# STATE OF MAINE DEPARTMENT OF TRANSPORTATION 16 STATE HOUSE STATION AUGUSTA, MAINE 04333-0016

January 18, 2013 Subject: **Auburn**

Federal Project No: AC-BR-1928(400)X

State WIN: 019284.00 Amendment No. 4

DETAILS SUPERSTRUCTURE ANDROSCOGGIN COUNTY AUBURN

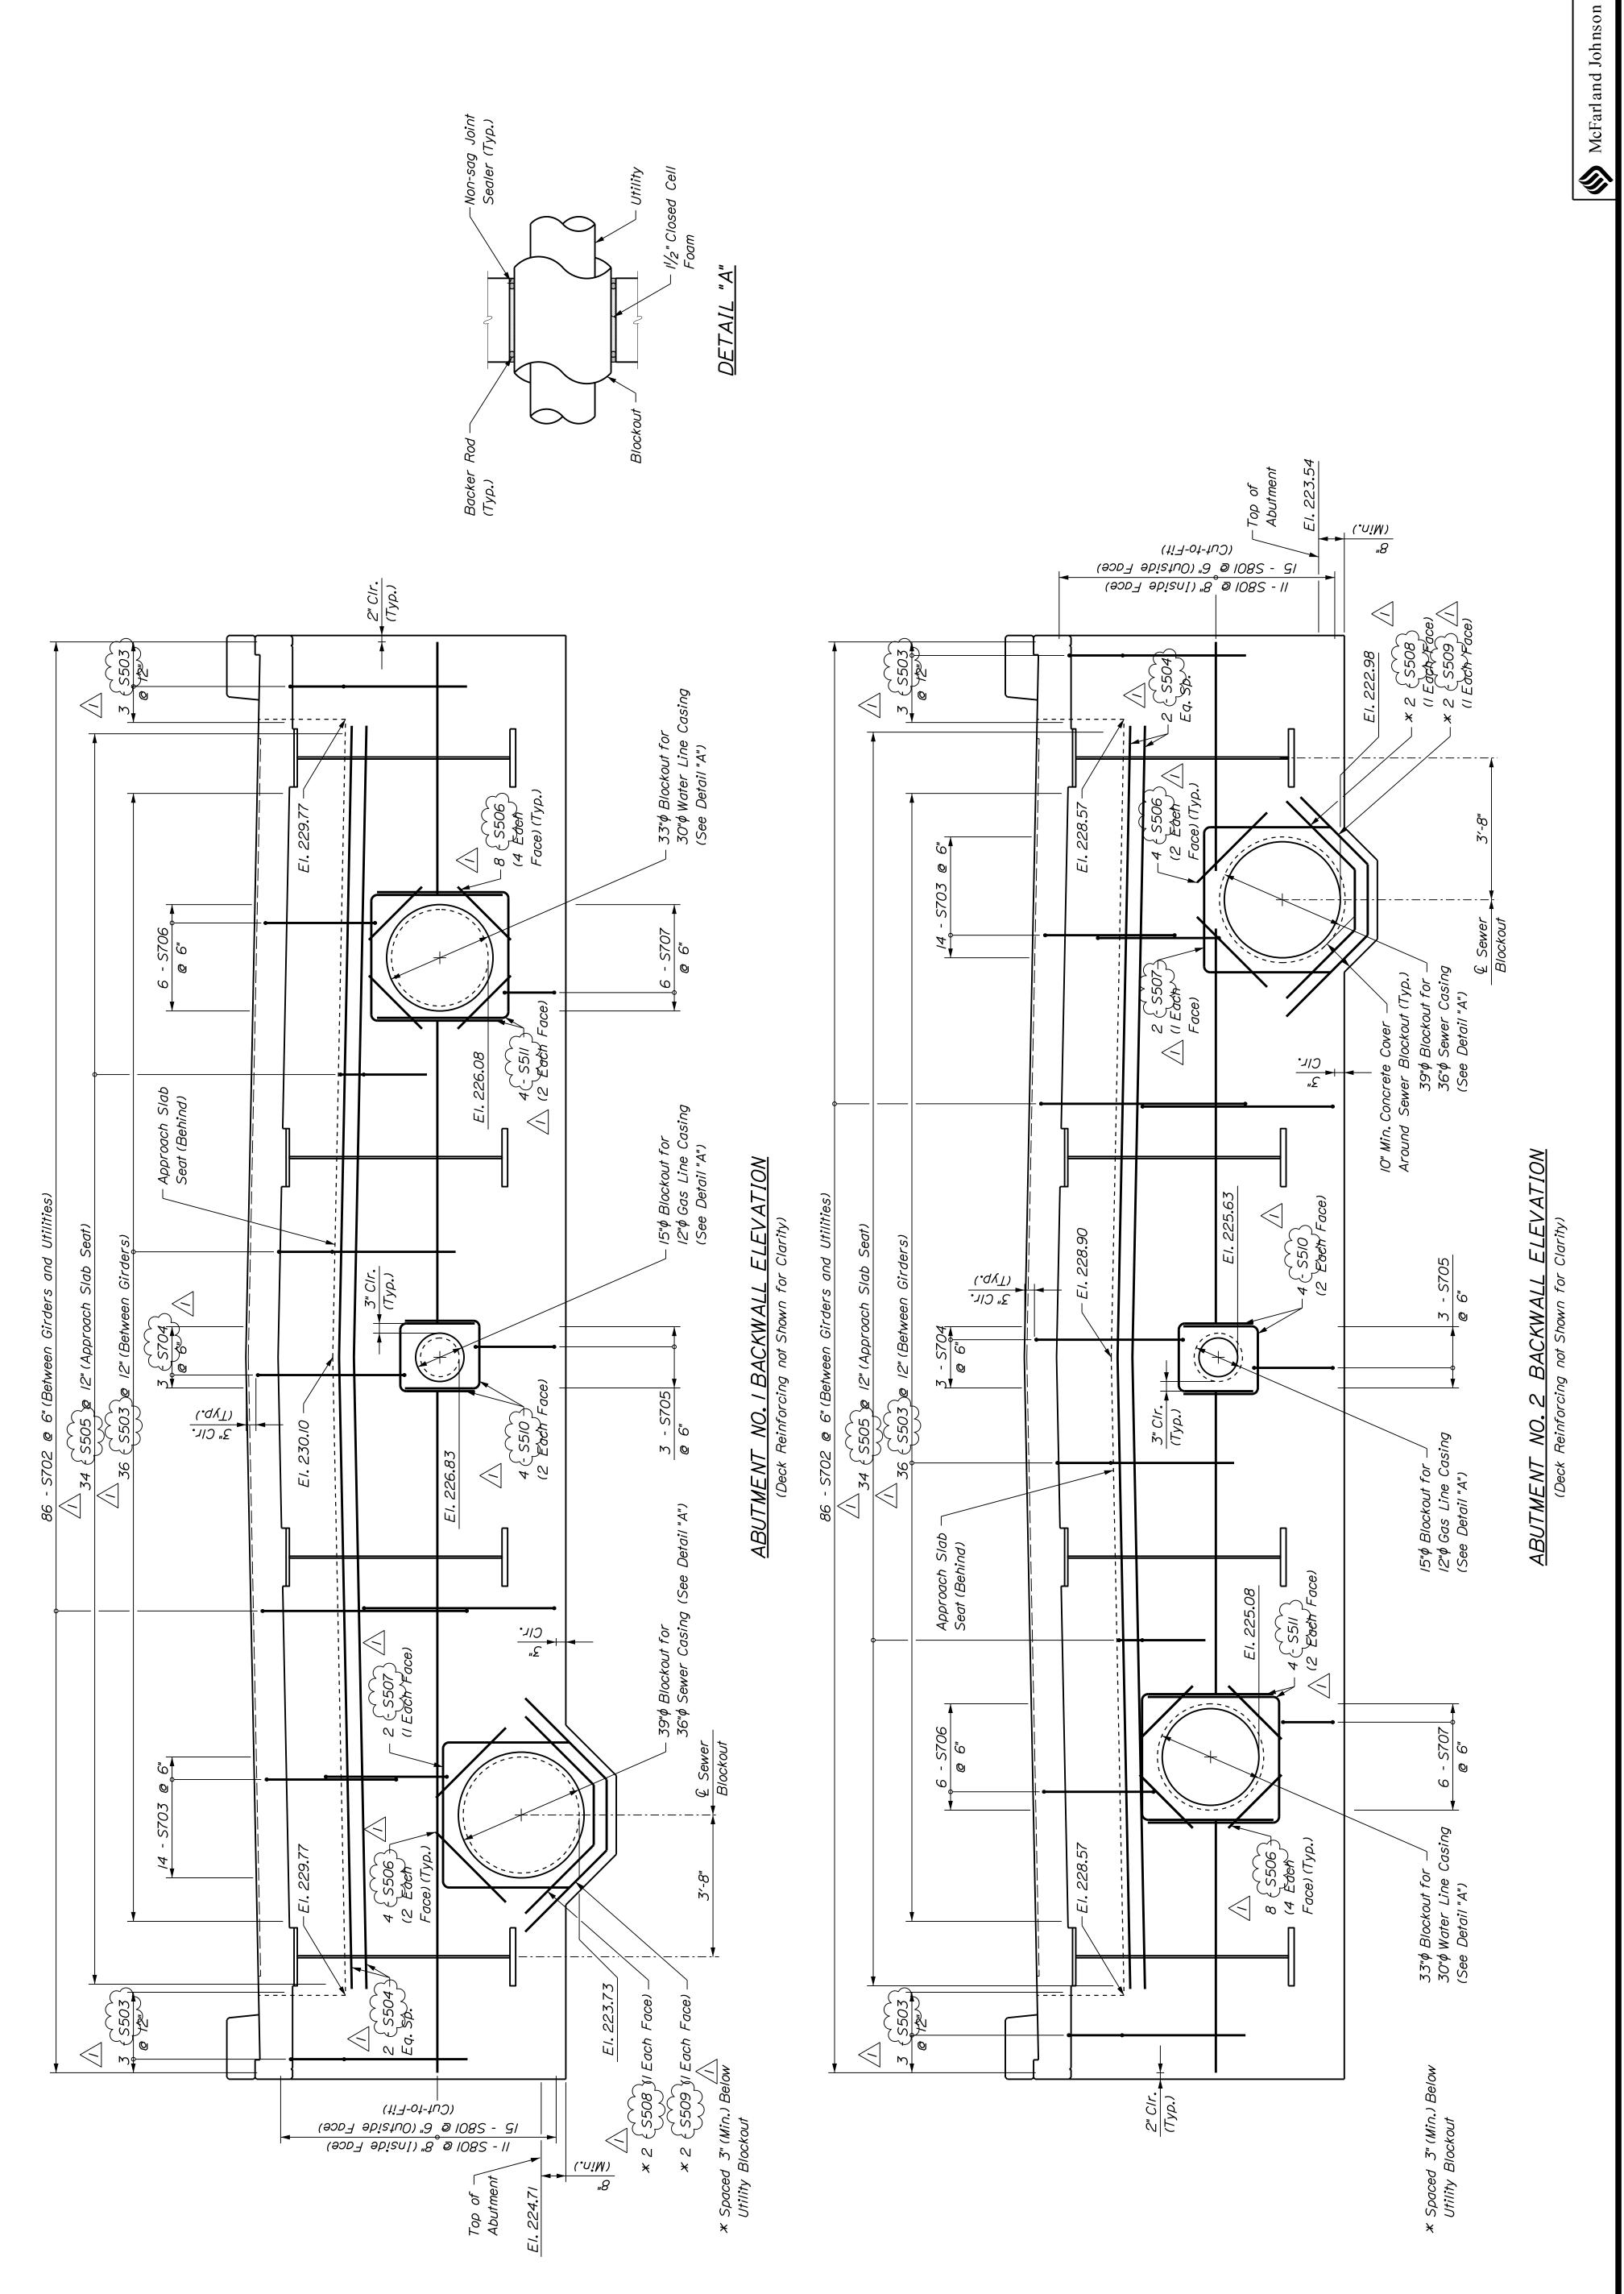
SHEET 36 OF 42 - SUPERSTRUCTURE DETAILS

Question: Sheet 37 requires tensioning strength of 145 KSI and modulus of 9000 KSI on bends marked S505, SS703, S704, S705, S706 and S707. We do not have a bend system

**Question:** On page 37, Bent Bar S 508 dimensions appear to be incorrect. There are no leg ("C") dimensions and others appear to be reversed. Please advise.

**Response:** The reinforcing size, required tensile strength and moduli have been revised. Reference revised plans sheets 29, 35, 36 & 37 for updated reinforcing requirements.
